| DRAWN Robert DuRall | 8/7/07 | SERVICE BULLETIN WSB IDU-III-23 (ANNUNCIATED SWITCH REPLACEMENT) | |

SERVICE BULLETIN

EQUIPMENT: IDU-III

BULLETIN NUMBER: WSB IDU-III-23 Revision A

Figure 3 TAWS INHIBIT Switch Wiring

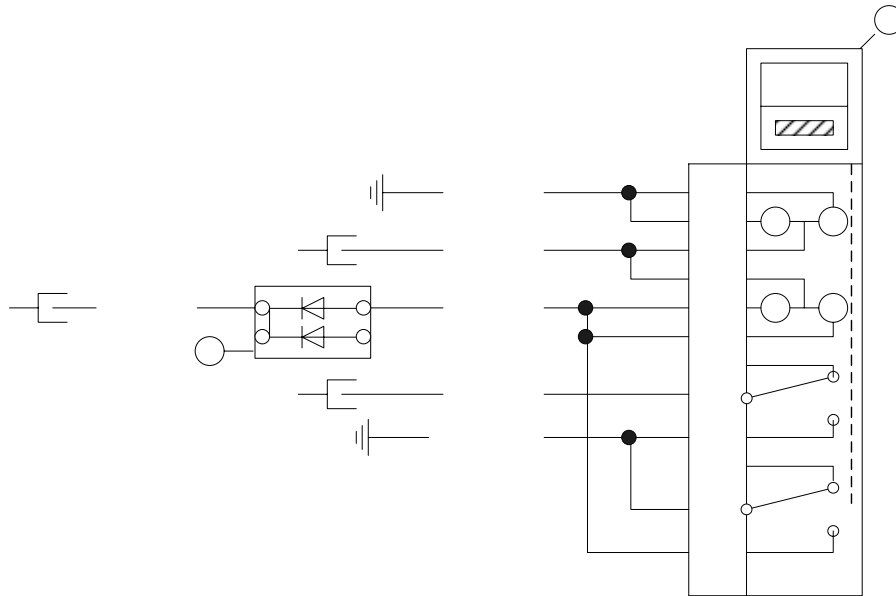
4. Determine if the existing pins are acceptable and re-pin as required for the new switch.
5. Install the new TAWS INHIBIT (Item 1) switch in the existing hole.
6. Wire the switch using the Aerospace Optics Connector Kit (Item 3) and existing aircraft wires as shown in Figure 3.

12. Install new TAWS INHIBIT switch (Item 1) in the hole.
13. Using the Aerospace Optics Connector Kit (Item 3) and existing aircraft wires; add new wires and a Diode Module (Item 4) to complete the installation as shown in Figure 3.
14. Connect the lighting power to the aircraft’s existing dimmer system.

Figure 4 Typical Annunciated Switch Cutout

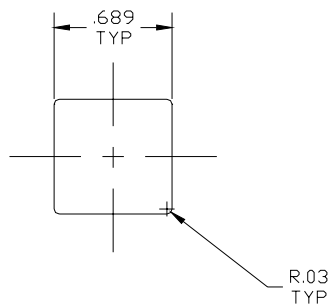
7. Secure the wiring as required.
8. Go to “LOW ALTITUDE SWITCH INSTALLATION” section.
9. Remove the TAWS INHIBIT toggle switch.
10. Use the existing ground wire and discrete wire for the new switch.
11. Cut a new hole using Figure 4 as guidance.

2. Cut a new hole using Figure 4 as guidance.
3. Install the new LOW ALTITUDE switch (Item 2) in the hole.
4. Using the Aerospace Optics Connector Kit (Item 3), a Diode Module (Item 4) and new wires, modify the aircraft to complete the installation as shown in Figure 5.
5. Connect the lighting power using the aircrafts' existing dimmer system.
6. Connect the Press-To-Test (PTT) wire to the aircrafts' existing PTT circuit.
7. Add a wire to the EFIS Interconnect Cable as shown in Figure 6.
